TEDS DESIGN EXCEPTION REQUEST

Project: Custom Industries
Site Address: 2300 Logos Drive Grand Junction, CO
City File Number: SPR-2008-251
Applicant: Ghiloni Properties, LLC
Representative: Vortex Engineering & Architecture, Inc.
Date: November 20, 2008

Re: TEDS Exception-2008-251

Transportation Engineering Design Standards (TEDS) Exception Approval / Denial Form

TITLE: SITE PLAN

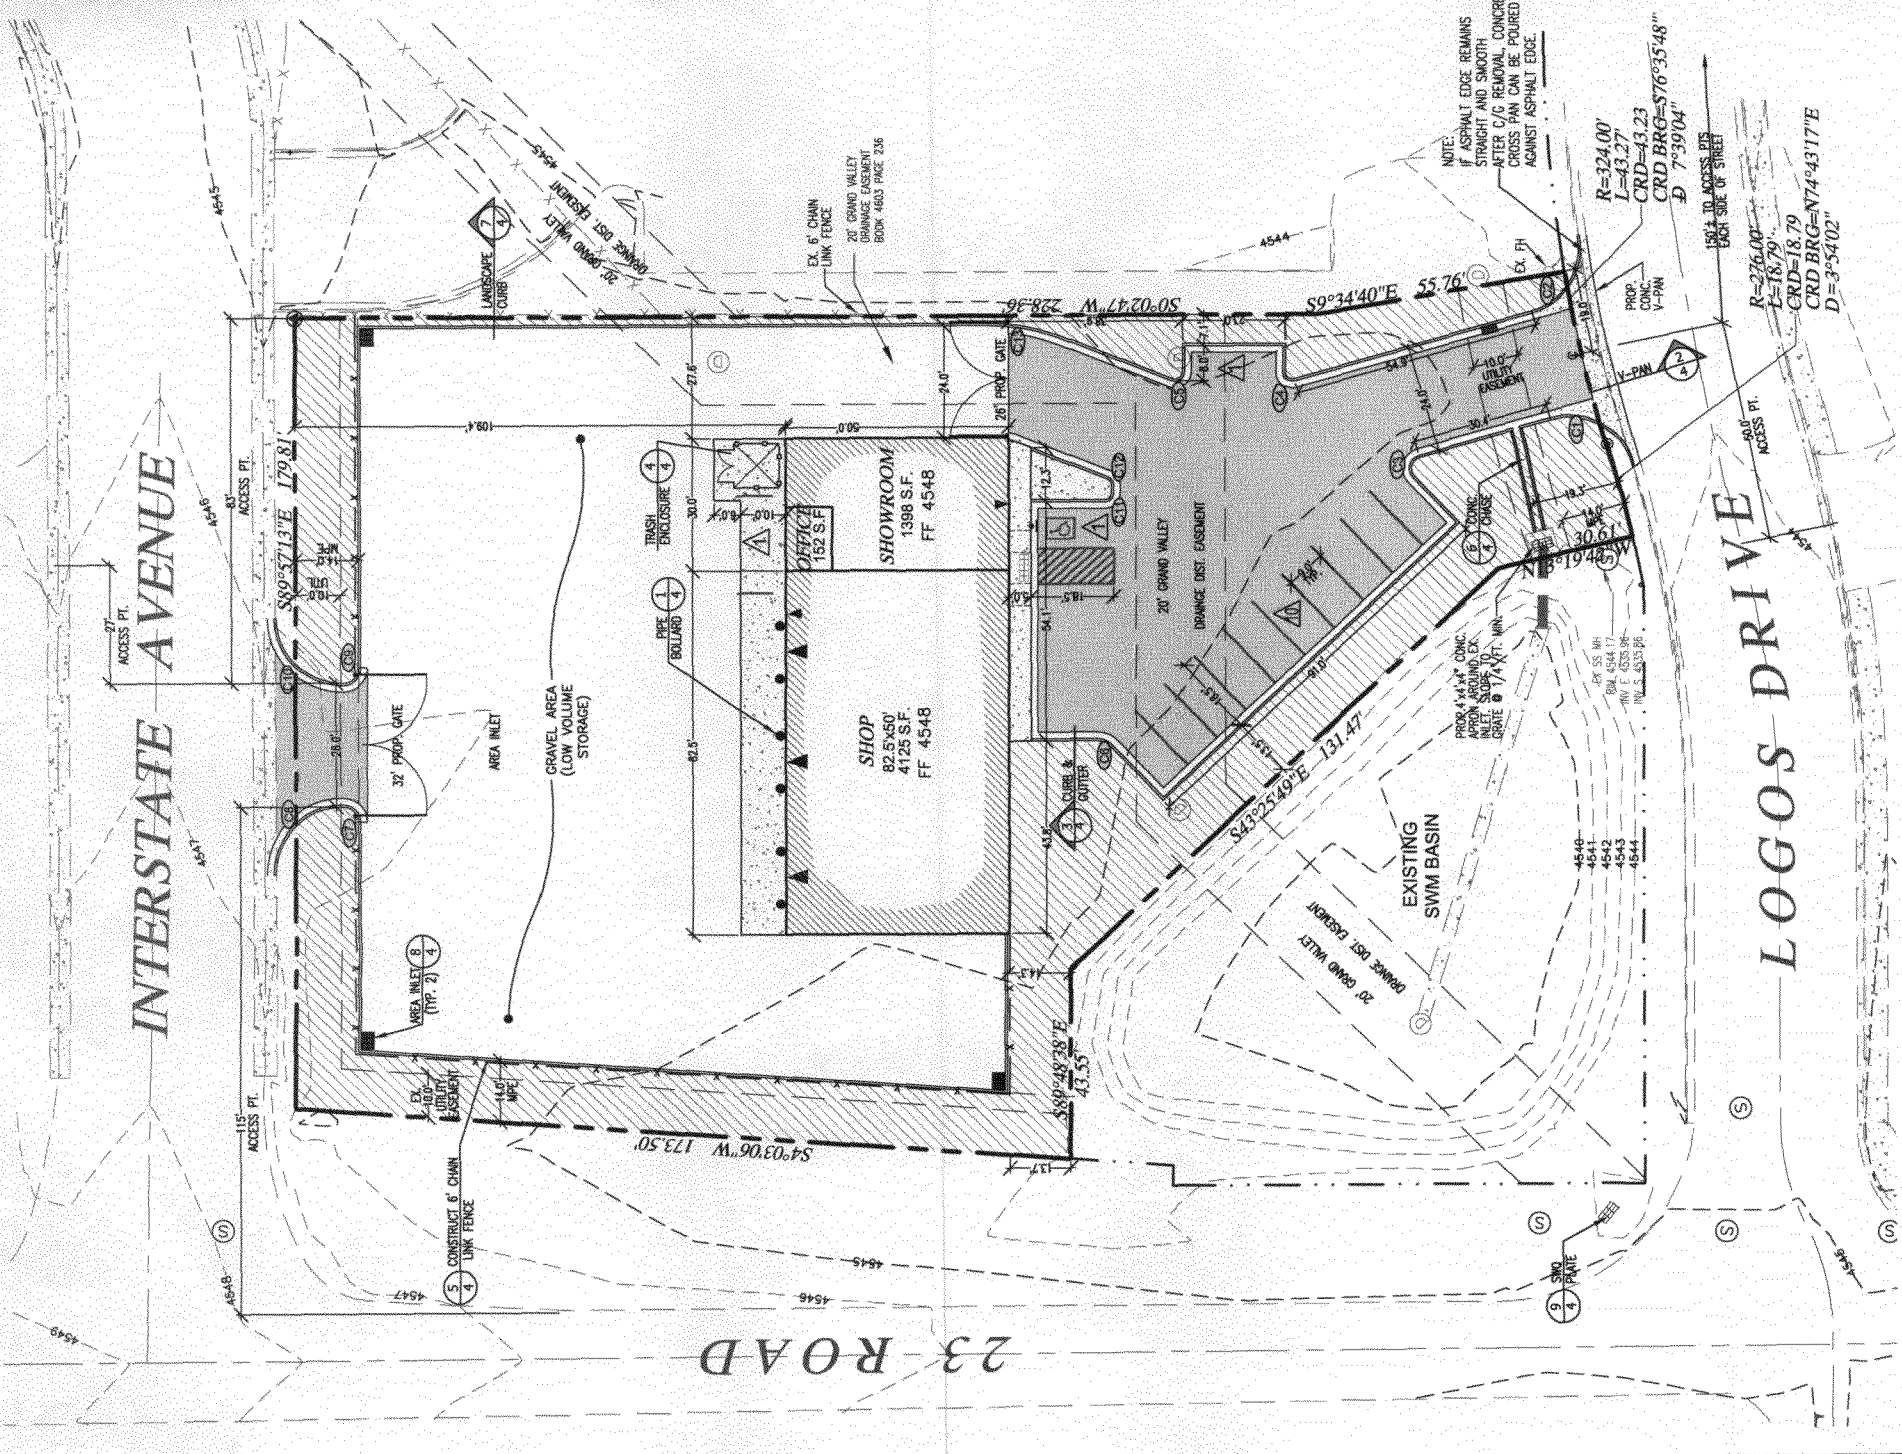
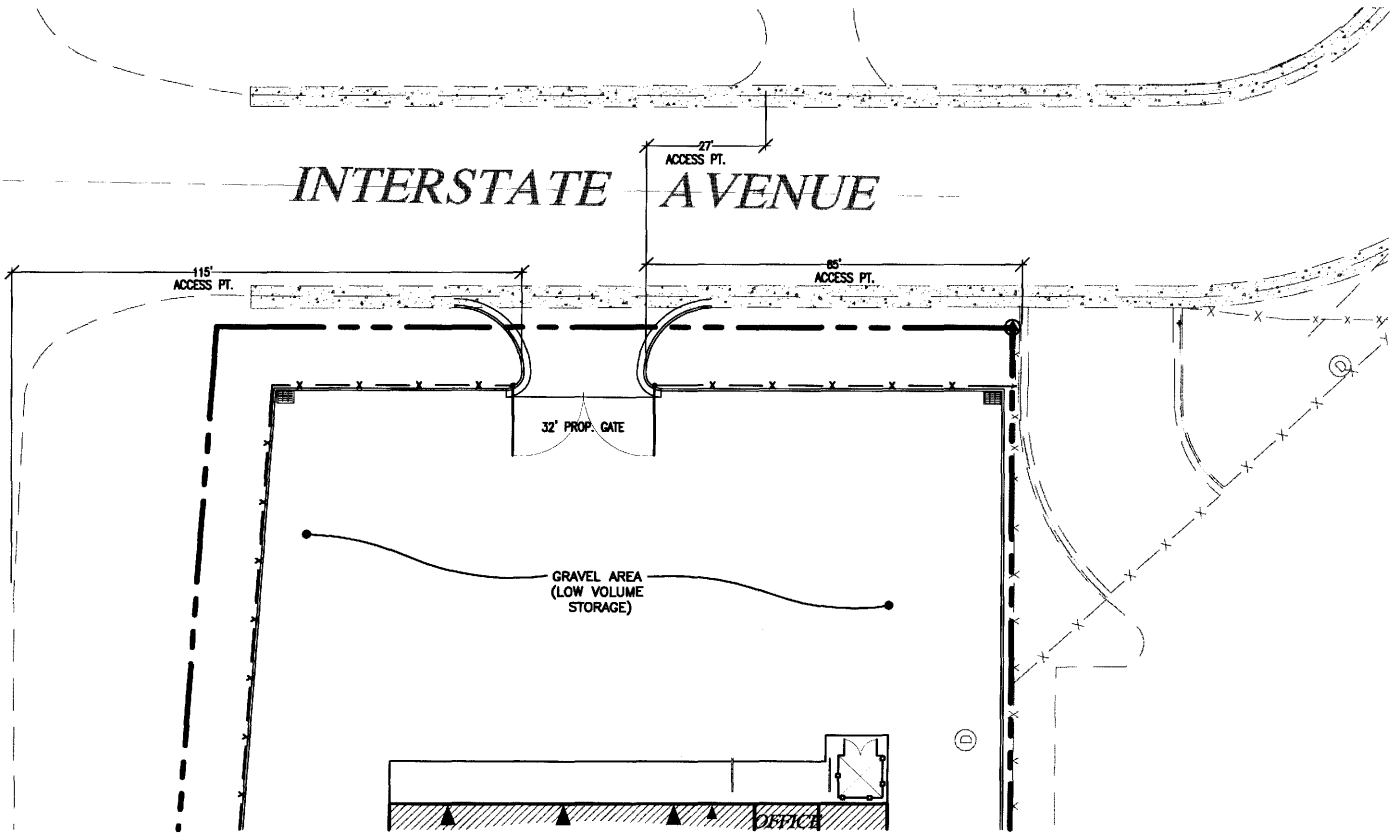
#1 Allow a gated secondary access from Interstate Avenue, a minor arterial, less than 150 feet from the un-signalized intersection (23rd Road). Section 4.1.3 Corner Clearance.

#2 Allow a gated secondary access from Interstate Avenue, a minor arterial, to have less than a 50 foot offset from a drive on the opposite side of the street. Section 4.1.2 Offsets.

#3 Allow a gated secondary access from Interstate Avenue, a minor arterial, to have less than a 150 foot spacing from the next drive on the same side of the street. Section 4.1.1 Spacing.

The proposed access would have a 27 foot offset from an opposite-side drive and an 85 foot separation from the next same-side drive which is also a gated entrance to a low volume storage area. (Measurements are edge to edge, not center to center)

The proposed access would be 115 feet from the flow line of the un-signalized intersection and on the outbound side, leaving the intersection.

Approved with the following modification(s): Move the entrance to align with the entrance on the north side of Interstate Avenue.

TEDS Exception Request #2: TEDS 4.1.2 Drive spacing opposite side: NO LONGER NEEDED

Comment: Access is gated. Traffic volume on Interstate is low.

TEDS Exception Request #3: TEDS 4.1.1 Drive spacing same side.

Approved as requested.
